# EPC DPW Stormwater\_2026-06-10\_007 - Drainage Report Markup Summary

**LOCATED AT  
BENT GRASS MEADOWS I  
IN EL PASO COUNTY, CC**

PCD File No. PPR2615

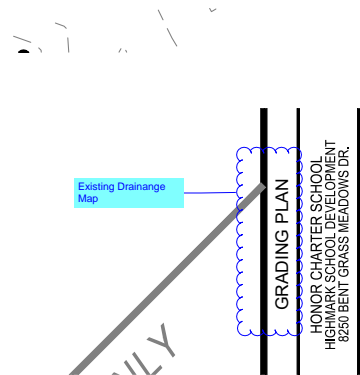
Include offsite basins.

Include offsite basins.

**RESPONSE: OFFSITE BASINS INCLUDED**

Existing Drainage Map

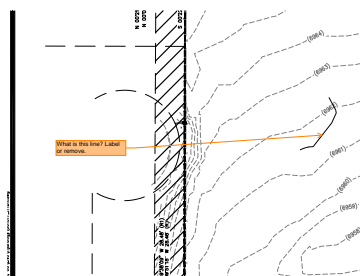
Add design points to exhibit.

Add design points to exhibit.

**RESPONSE: DESIGN POINTS ADDED**

**RESPONSE: TITLE UPDATED**

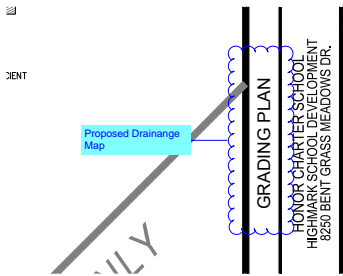
What is this line? Label or remove.

**RESPONSE: REMOVED**

Proposed Drainage Map

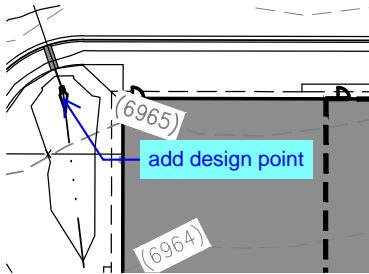
Include offsite basins.

Include offsite basins.

RESPONSE: INCLUDED

RESPONSE: TITLE UPDATED

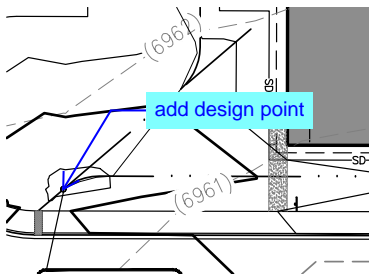
add design point

RESPONSE: ADDED

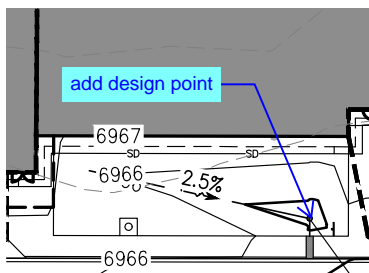
add design point

RESPONSE: ADDED

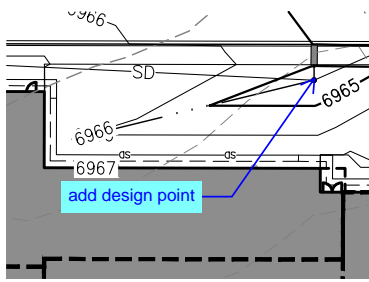
add design point

RESPONSE: ADDED

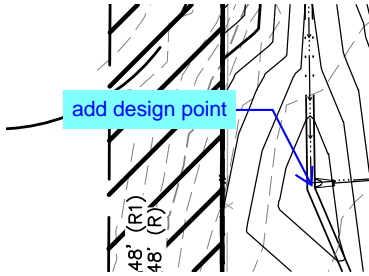
add design point

RESPONSE: ADDED

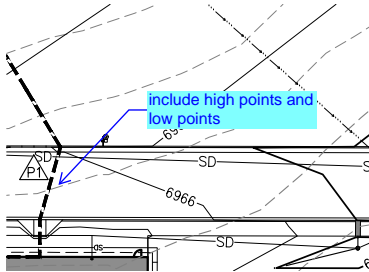
add design point

RESPONSE: ADDED

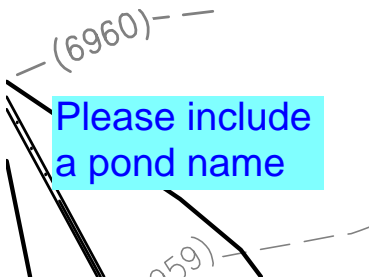
include high points and low points

RESPONSE: ADDED
